**To:** EPA  
**Copy To:** File 80021  
**From:** J. Lambert, J. Brunelle  
**Subject:** Olin: Proposed Steam Gauge Location Review Comments  
**Date:** 7/29/19

#### Stream Gauge Locations – MMB and North of Olin

#### Olin Chemical Superfund Site Wilmington, Massachusetts

**Subject:** Review of Olin's revisions to EPA Geophysical Alignments proposed during meeting of June 26, 2019

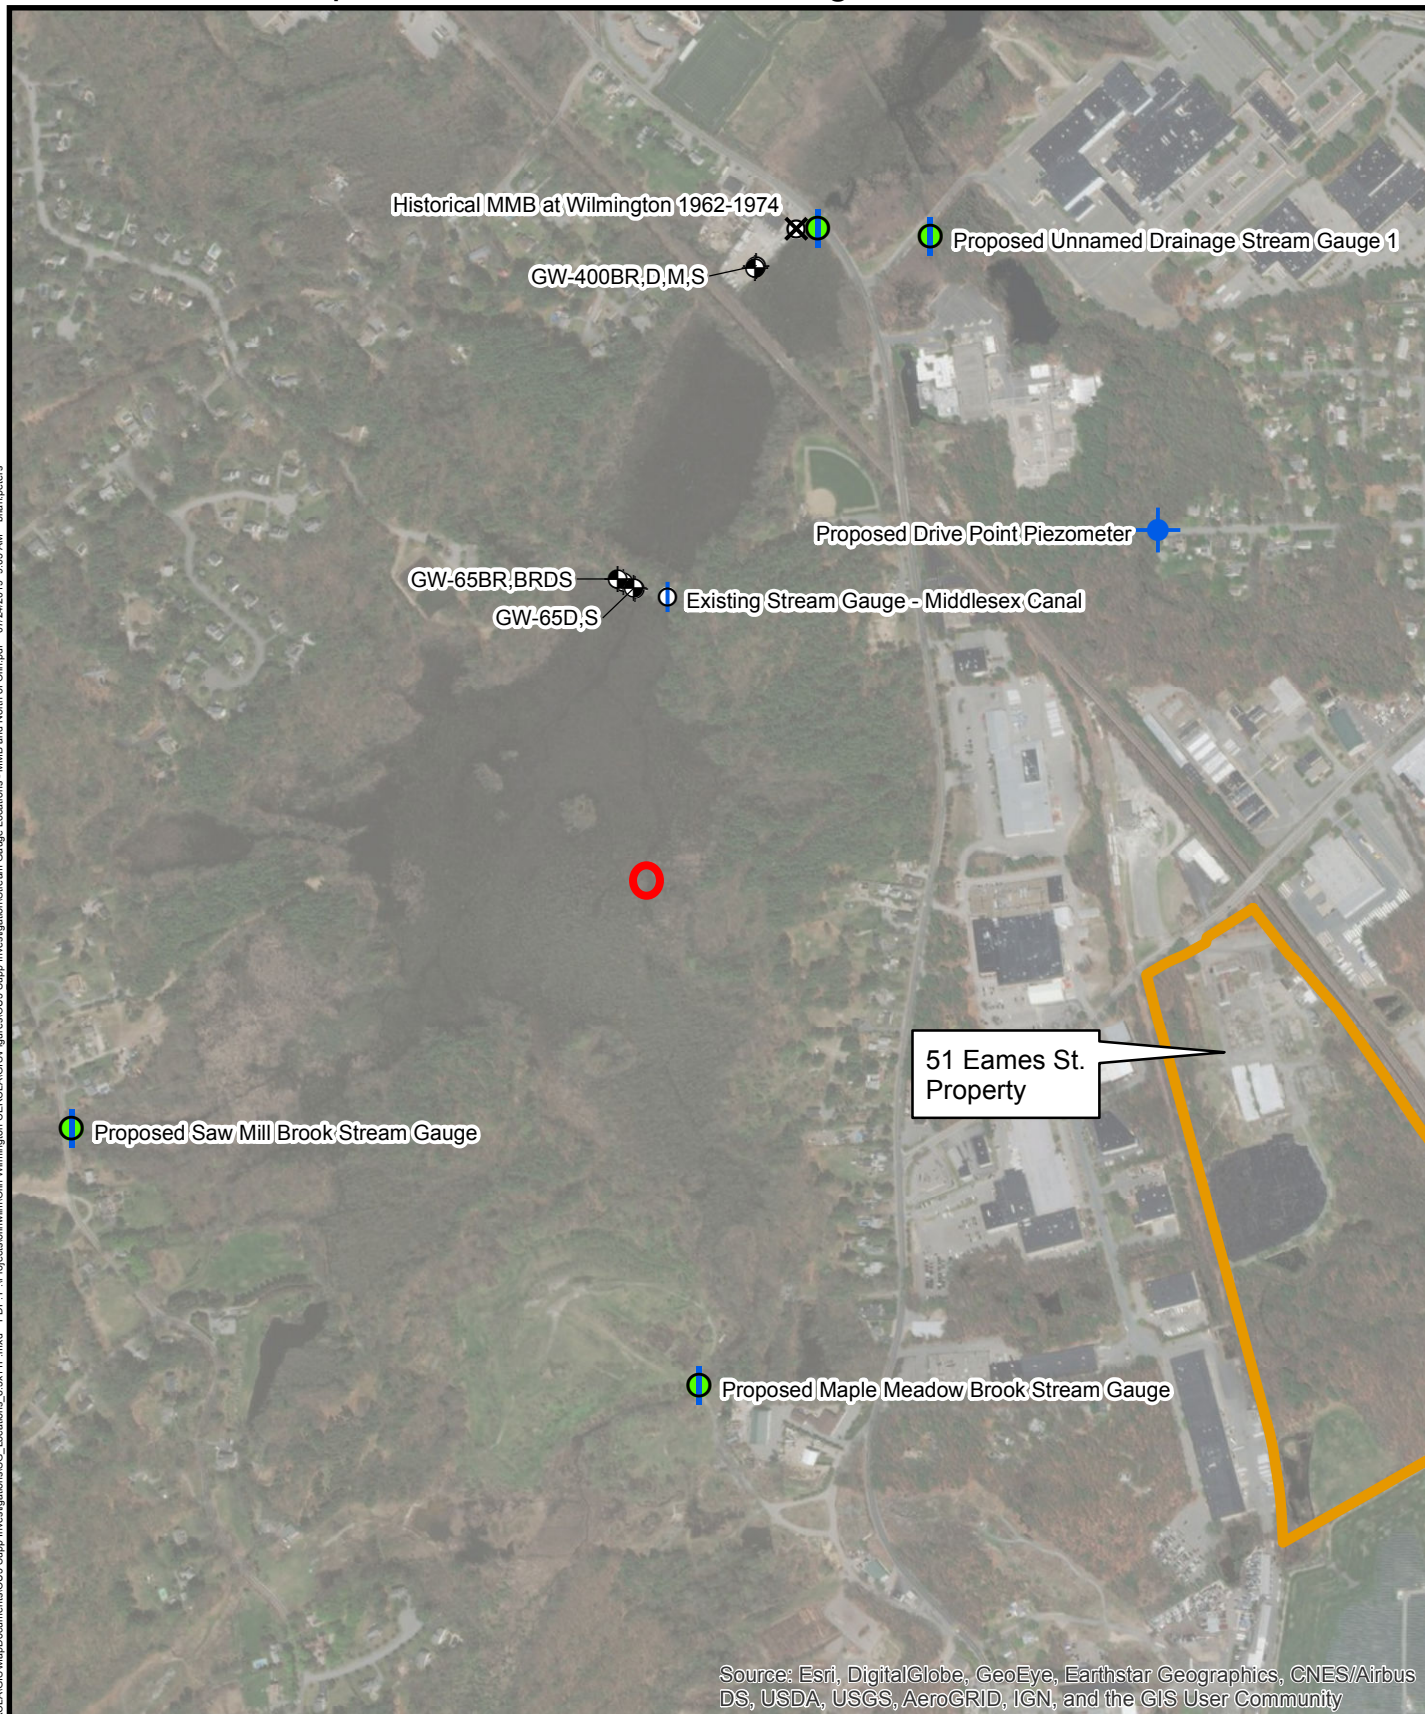
1. The proposed Maple Meadow Brook (MMBW) stream gauges are appropriately located for evaluating major inputs and outlets of the MMBW as well as for comparison to previous surface water elevation data.
2. The proposed surface water gauges north of Eames Street and at the upper South Ditch are also appropriately located.
3. Olin should install a stream gauge on the east side of the MMBW to gauge groundwater in the core of the MMBW plume. The general location of the proposed gauge, as shown on the attached figure, is along the southern edge of the Town-owned parcel and at the edge of the wetland to minimize access concerns.
4. Olin should install the proposed Lower South Ditch gauge as close to the East Ditch as practical without interfering with the potential maintenance of the railroad line.

○ = potential additional SW Gauge Location
